## Amendments to the Drawings:

## **REMARKS / ARGUMENTS**

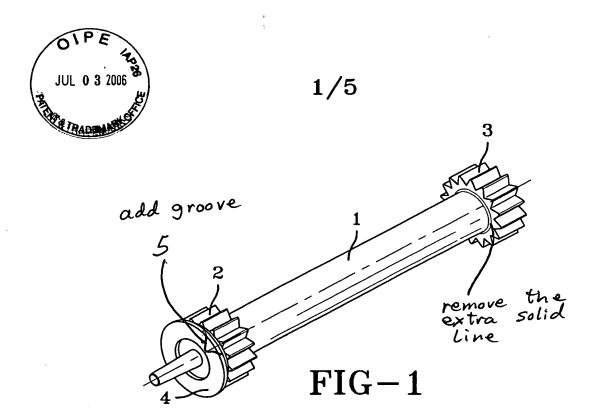
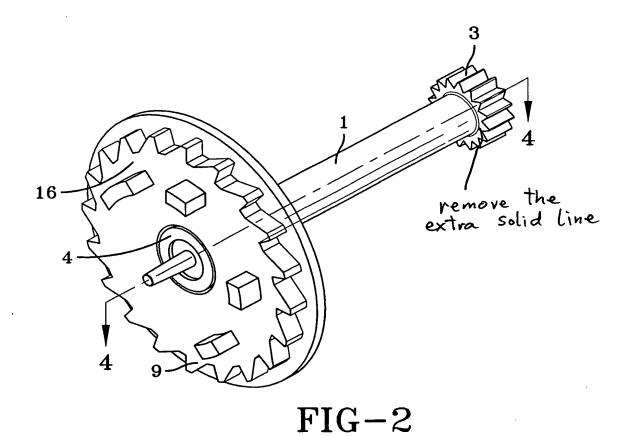
The replacement drawings for figures 1, 2, 4, 5, 6, 7, 8, 9, 10 and 11 better reflect the depth of the gear teeth. In figure 1 extraneous lines were removed and the groove reference number 5 was added with a cut out portion to show the groove 5 better. In figures 1 and 2 an unneeded line near the gear 3 was deleted. In figures 4 - 10 the trough of the gear teeth was shown as a dashed line. In figure 11 more cross hatching was added to better show the component features.

Drawing figures 1, 4, 5, 6, 7, 8, 9 and 10 have been corrected to show the trough of the gear teeth being less radially deep as compared to the circumferential groove. No new matter has been added. The corrections clarify the drawings that were objected to by the examiner. Figures 2 and 11 were also amended to provide a clearer view. Withdrawal of this rejection is respectfully requested. Replacement sheets are being filed herewith.

FIG-5

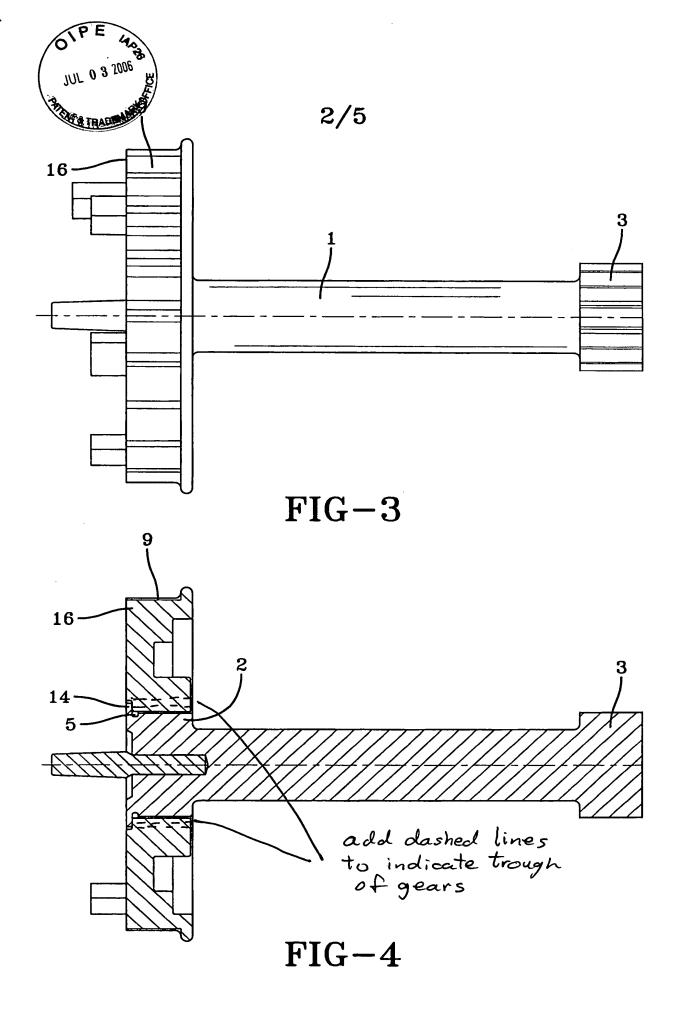
add dashed lines to each of these figs to indicate trough of gears
